# CONVAIR

## COMMERCIAL CHANGE PROPOSAL

SPEC NO.: ZD- 22-321

CUSTOMER: AVENSA

# INTERIOR SEATING ARRANGEMENT

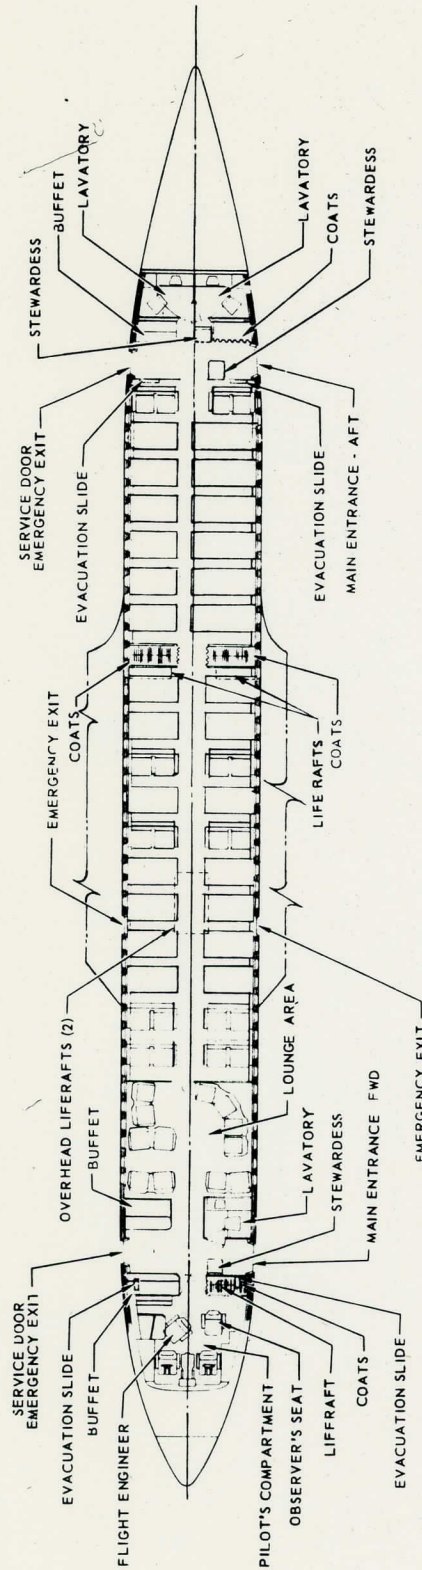
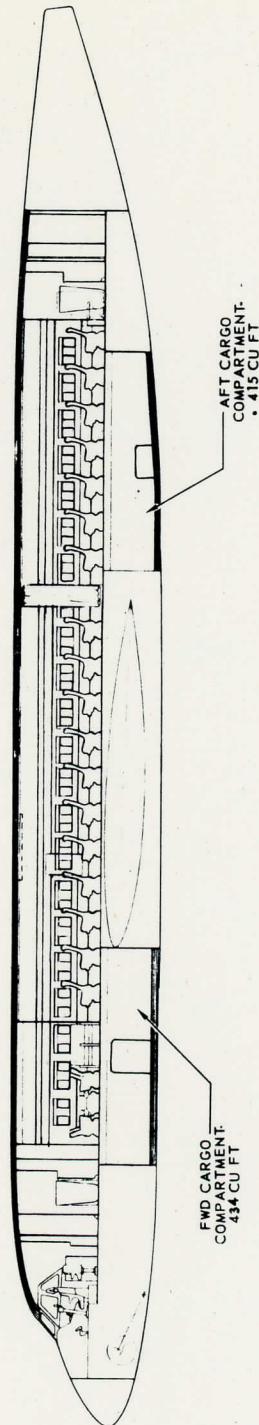
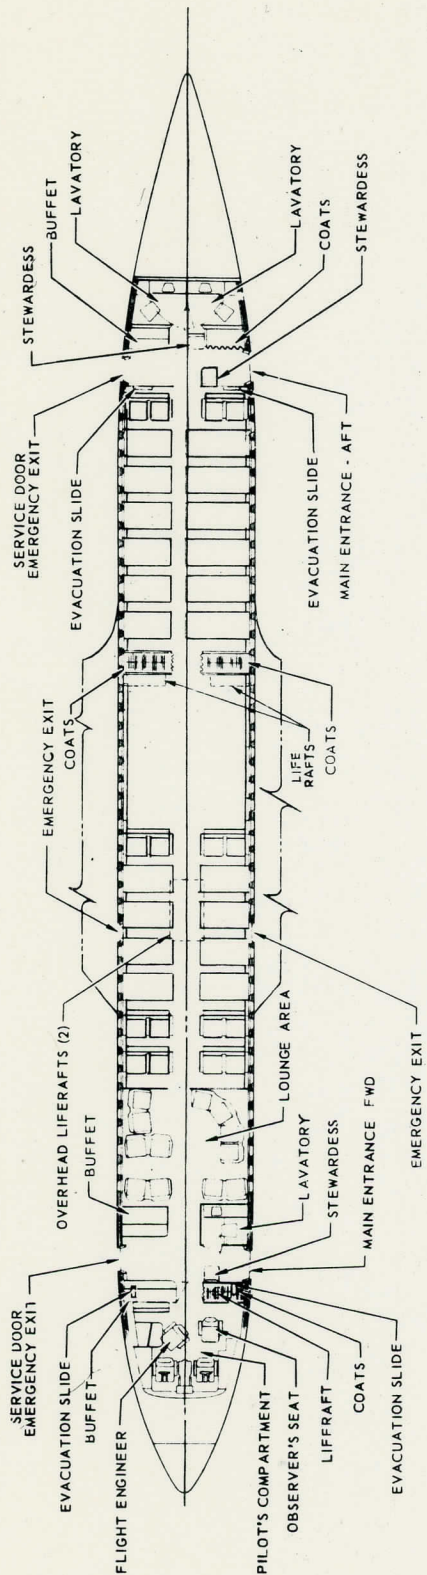
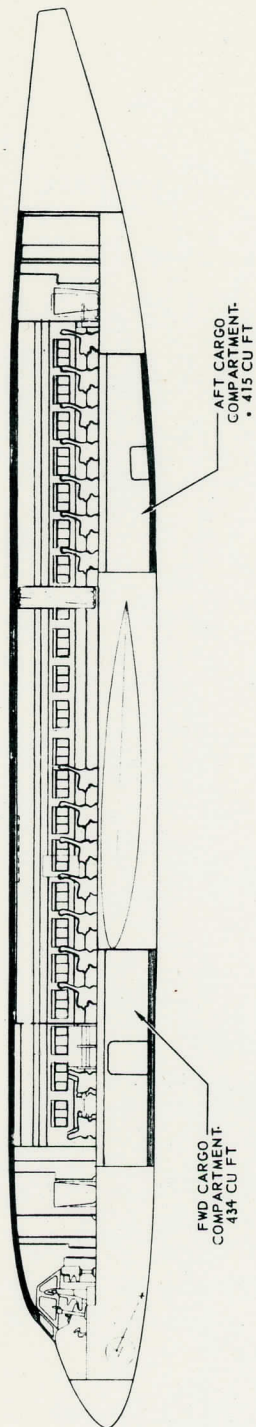
Replace above illustration in the specification with Enclosure (A) which indicates that this illustration is applicable to No. 1 Airplane only.

Add above page (Enclosure (B)) to the specification, which is identified as applicable to No. 2 Airplane.

Page 6-1, Add this page (Enclosure (C)) to the specification, which is only applicable to No. 2 Airplane.

To: "The standard interior arrangements of these airplanes shall be as shown on "Page 3b - INTERIOR SEATING ARRANGEMENT" for No. 1 Airplane, and "Page 3c - INTERIOR SEATING ARRANGEMENT" for No. 2 Airplane."

GENERAL ARRANGEMENT

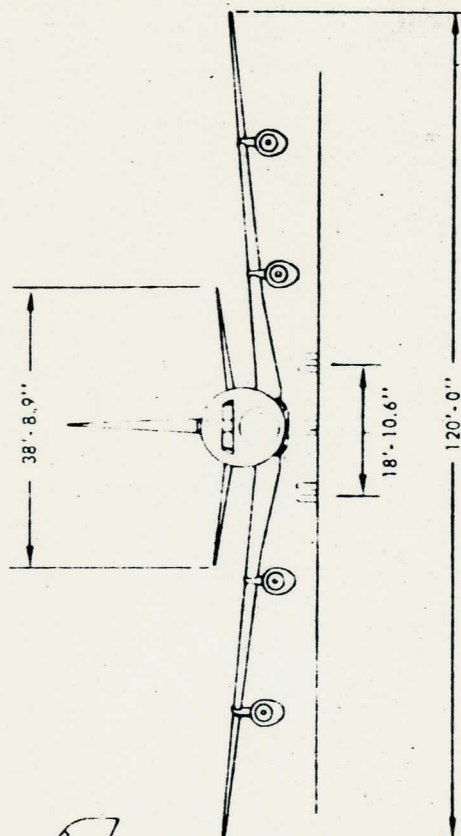
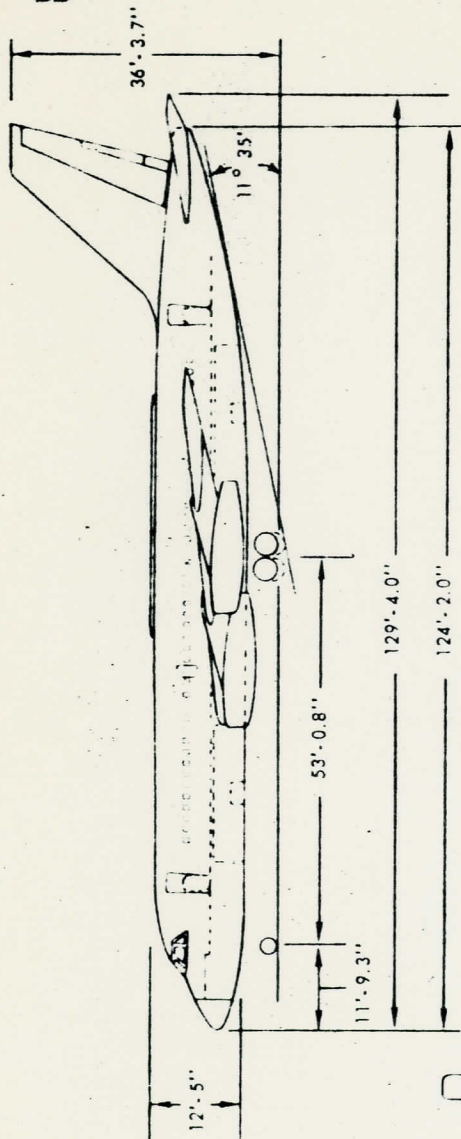
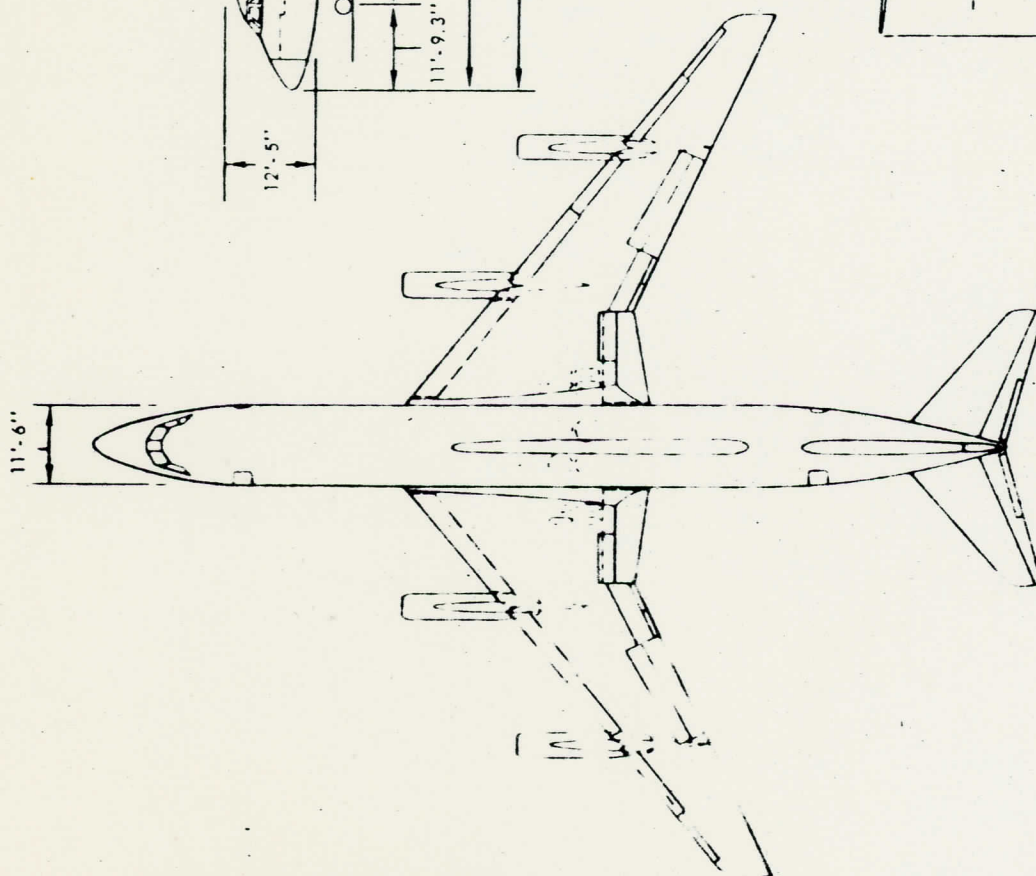
Replace above illustration in the specification with Enclosure (A) which shows Krueger Flap installation between inboard pylon and fuselage, and trailing edge inboard flap extension.

Enclosure (A) One copy Page 45a - PITOT STATIC SYSTEM (Revised)

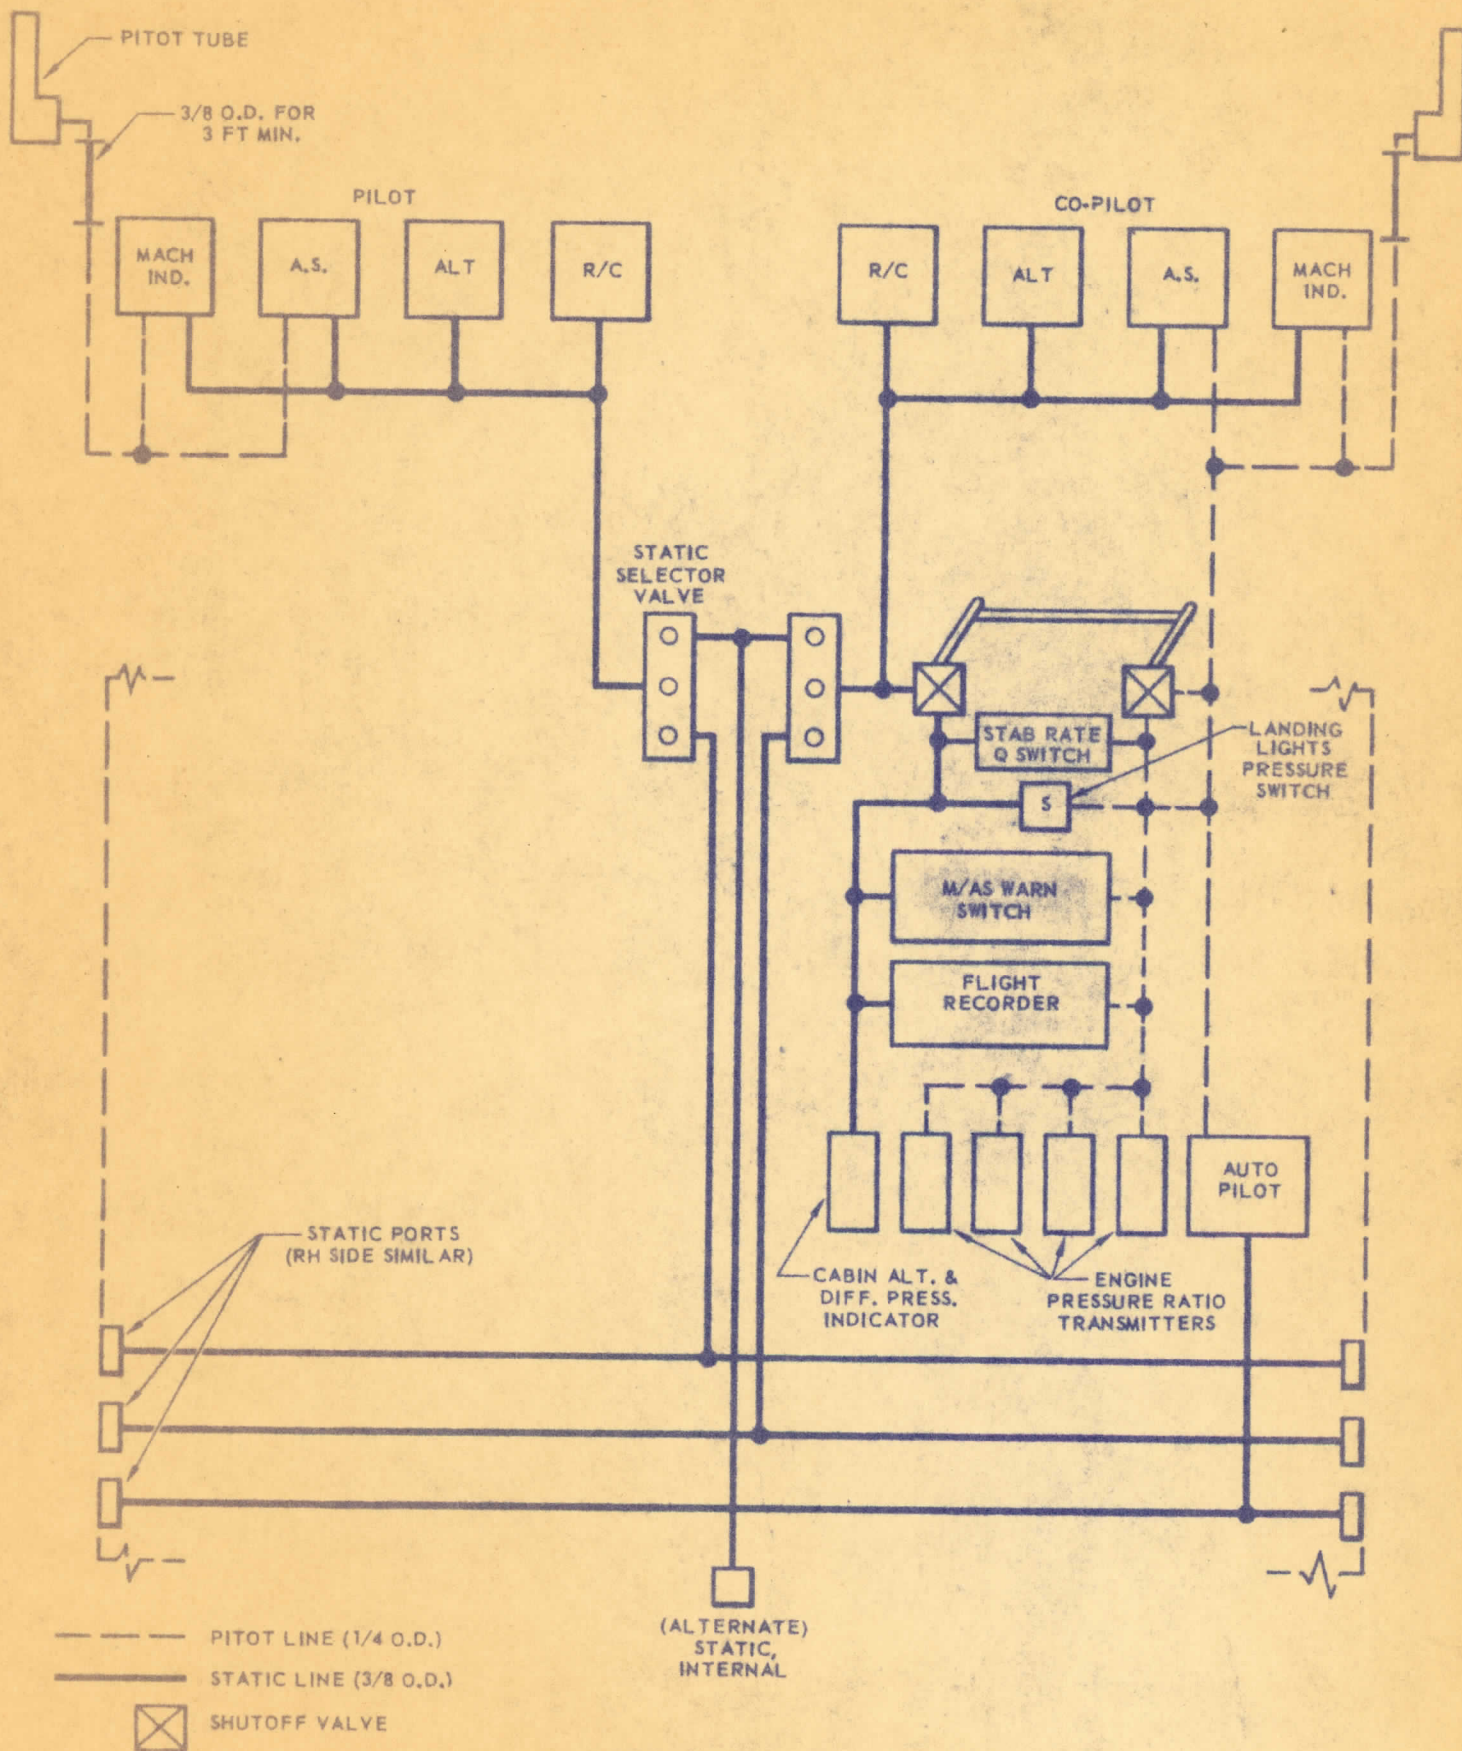
Replace above illustration in the specification with Enclosure (A) which shows Flight Data Recorder installed.

Enclosure: (A) One copy Page 44a - PILOT'S AND COPILOT'S CONSOLE  
AND WING PANELS (Revised)

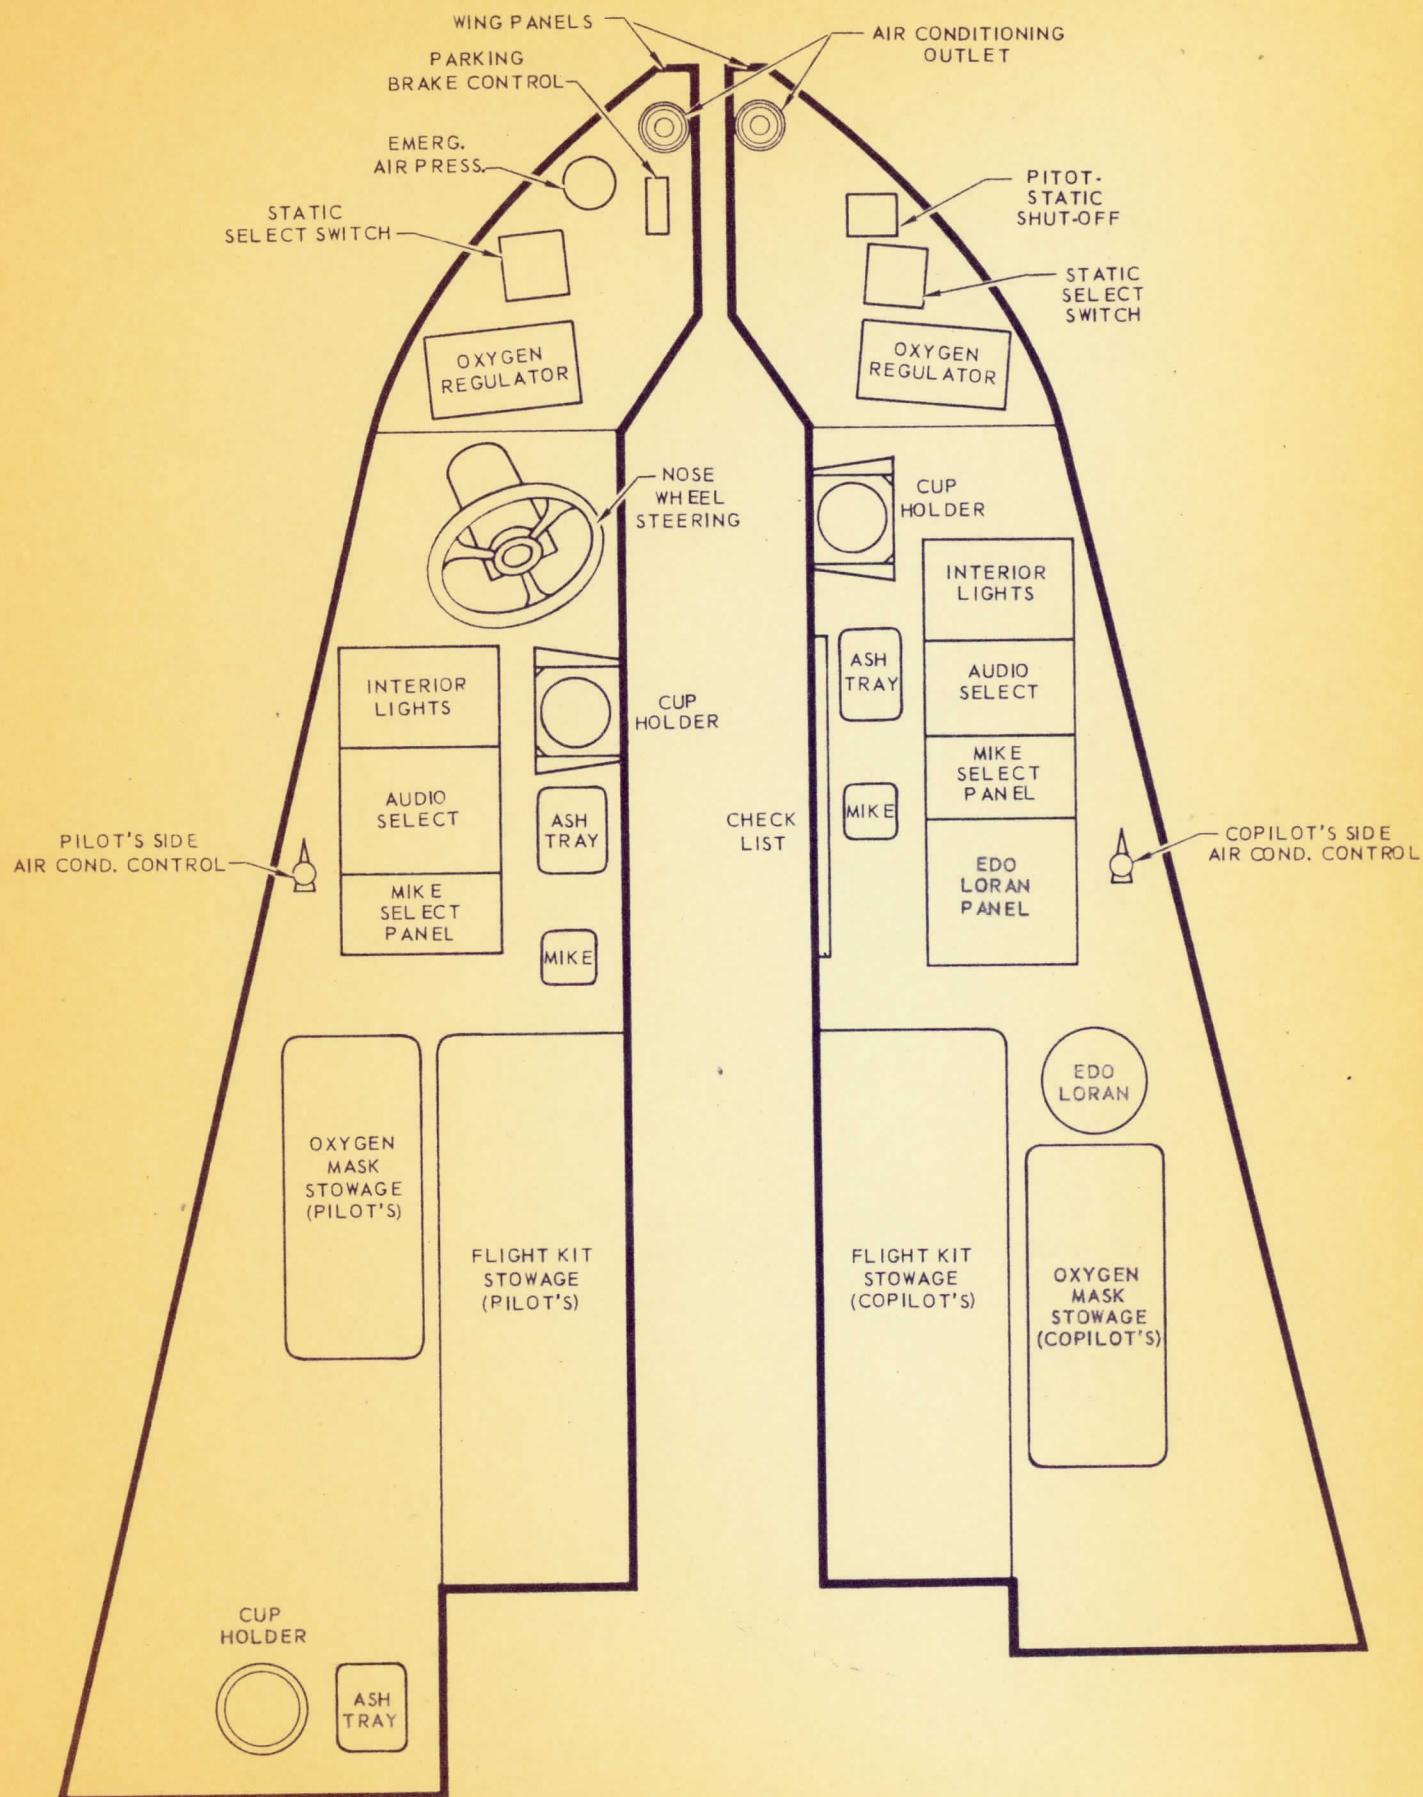
Replace above illustration in specification with Enclosure (A)  
which shows "Edo Loran" and relocates copilot's oxygen mask stowage.

Page 7a, C. G. DESIGN LIMITS:

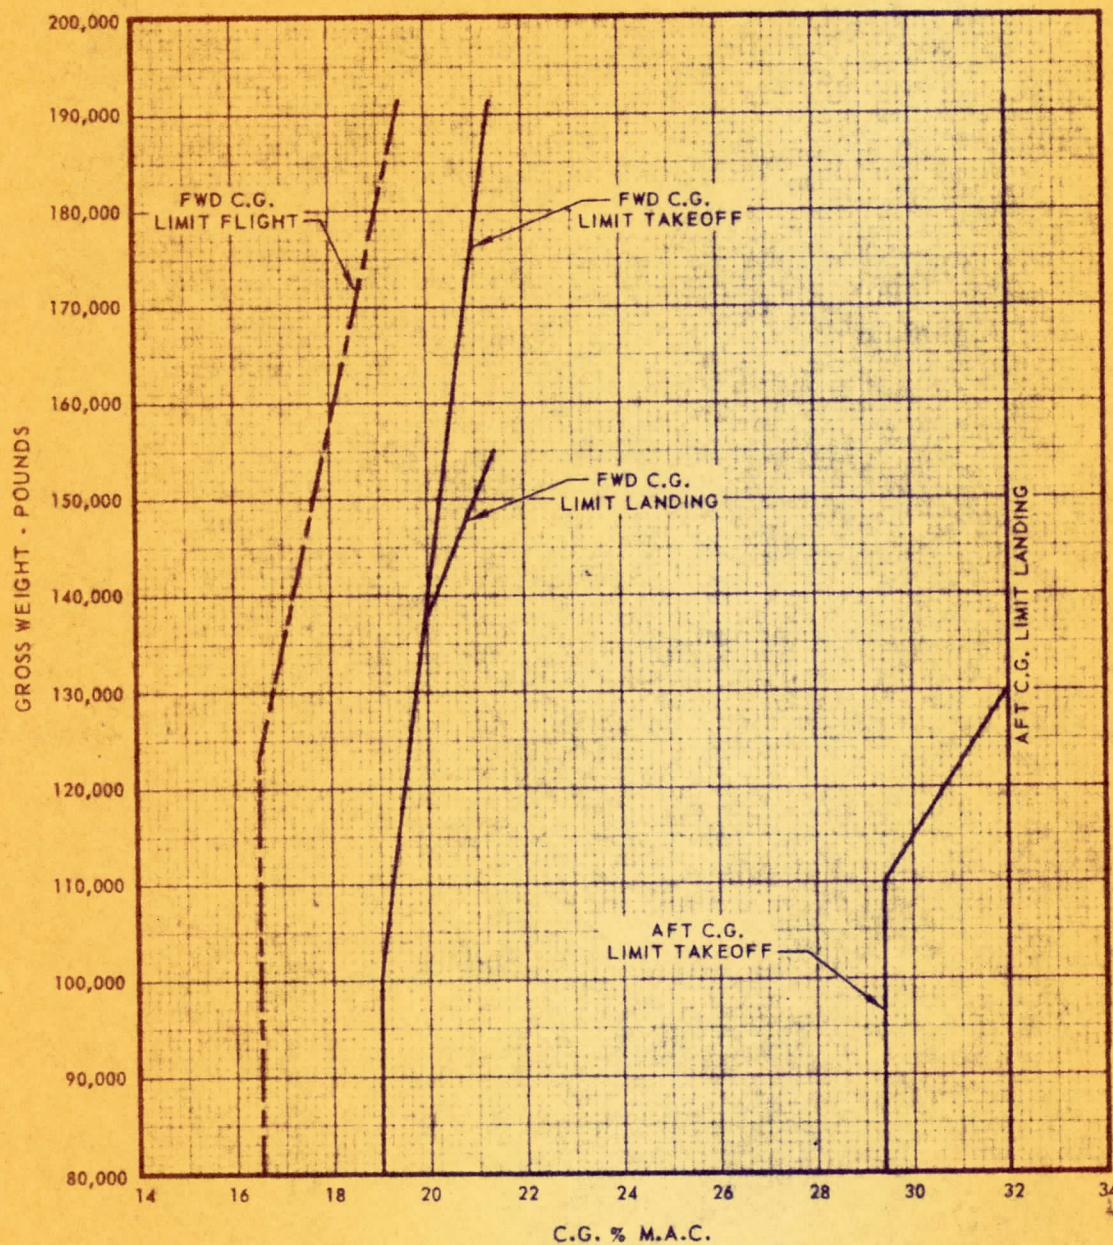
Replace above illustration in the specification with Enclosure (A) which adds new aft C. G. Limit takeoff and landing.
